## PLANNING COMMISSION AGENDA REPORT

**SUBJECT:** REVIEW OF A MIXED-USE PROJECT WITH A 24% DENSITY BONUS, INCLUDING A MINOR USE PERMIT, CONSISTING OF 94 RESIDENTIAL UNITS AND 924 SQUARE FEET OF COMMERCIAL SPACE. AN ADDENDUM TO THE PREVIOUSLY APPROVED MITIGATED NEGATIVE DECLARATION HAS BEEN PREPARED.

**PROJECT ADDRESS:** 279 Bridge Street

**FILE NUMBER:** ARCH-0587-2020,  
USE-0412-2021, AFFH-0413-2021&  
EID-0494-2021

Figure 2: Section Cuts demonstrating compliance with Edge Conditions setbacks, the balconies referenced are located on Section Cut 1, 2 and 4.

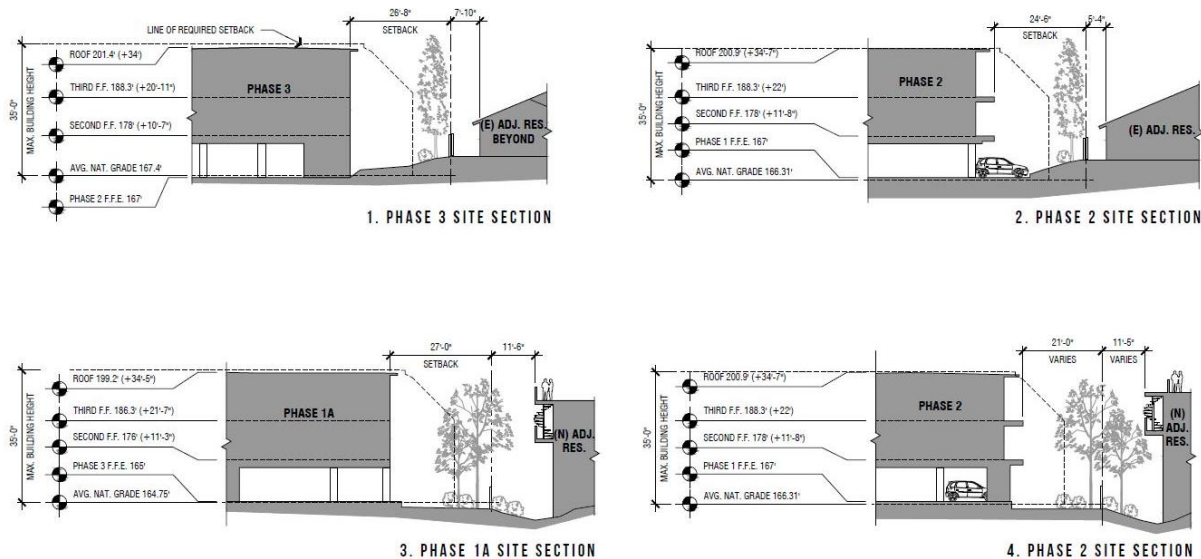
Edge Conditions: The Zoning Regulations § 17.70.050 (Edge Conditions) is intended to provide a buffer between low-density residential zones or open space areas and zones that permit development of higher intensity. These regulations require specific development standards along the property line that transitions from a lower intensity zoning, such as the adjacent R-2 zoning to the east and south of the subject property. The Edge Conditions regulations stipulate that balconies are prohibited above the first floor on the building side facing the R-2 zone (§17.70.050.D.3). The Edge Conditions standards also require that window placement on the proposed building be offset horizontally by 12 inches from any windows located on buildings on the adjacent properties in the R-2 zone (§17.70.050.D.5). The intention of these restrictions is to preserve privacy for adjacent lower-intensity developments. The project is requesting an affordable housing alternative incentive to allow for balconies on the second and third floors on the building side facing adjacent properties that are zoned R-2. The project also includes a waiver from the site development standard that requires window placement to be offset by 12 inches from adjacent existing structures along the second and third floors. The requested alternative incentive and development standard waiver are discussed in more detail in Section 5.3 below.

Alternative Incentive Request: Reduction to Site Development Standards: The applicant is requesting an alternative incentive to reduce site development standards to allow for balconies on the second and third floors on the building side facing an adjacent property that is zoned medium density (R-2). As mentioned earlier, balconies are prohibited above the first floor on the building side facing a property located within the R-1 or R-2 zones. The proposed project is surrounded by R-2 zoning to the east and south of the site.

The requested concession to allow balconies on the second and third floors will not create a specific or adverse impact because the balconies are setback from the adjacent property line by more than 20 feet, which provides adequate separation to preserve privacy and avoid direct overlook.
